P-9218-2

S2149

ISSUE-2

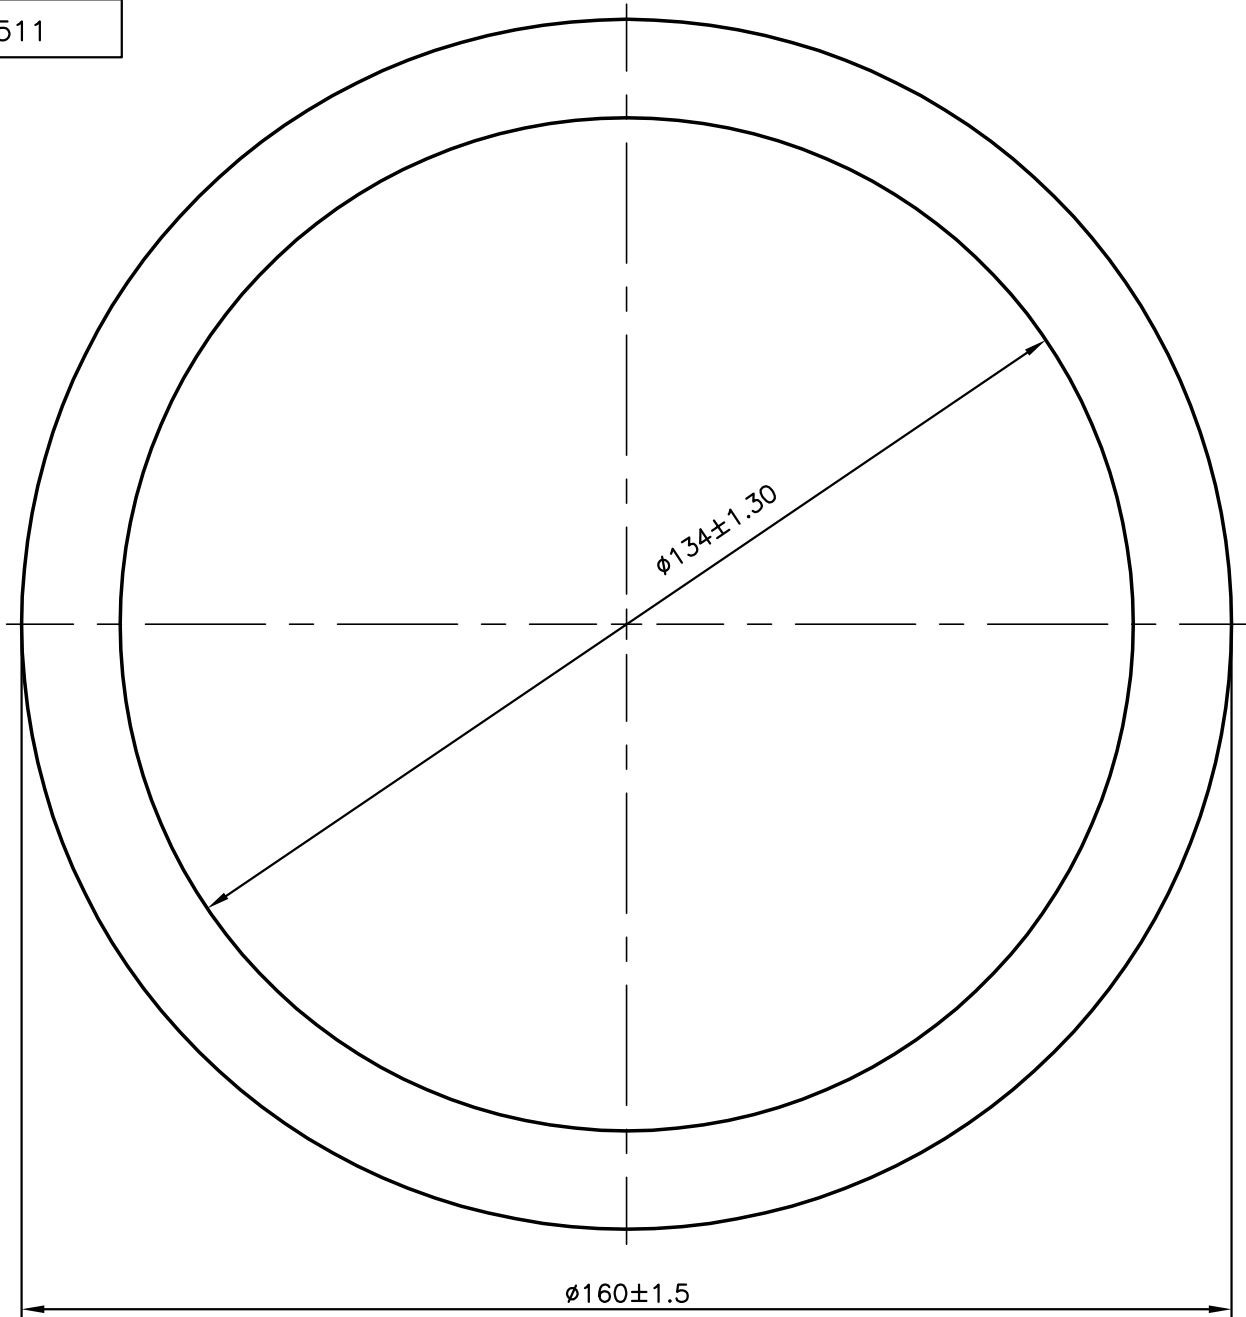
O.D. CHANGED FROM $\phi 155$ TO $\phi 160$, I.D. CHANGED FROM $\phi 140$ TO $\phi 134$
 WEIGHT ALSO CHANGED FROM 9.384 kg/M TO 16.210 kg/M
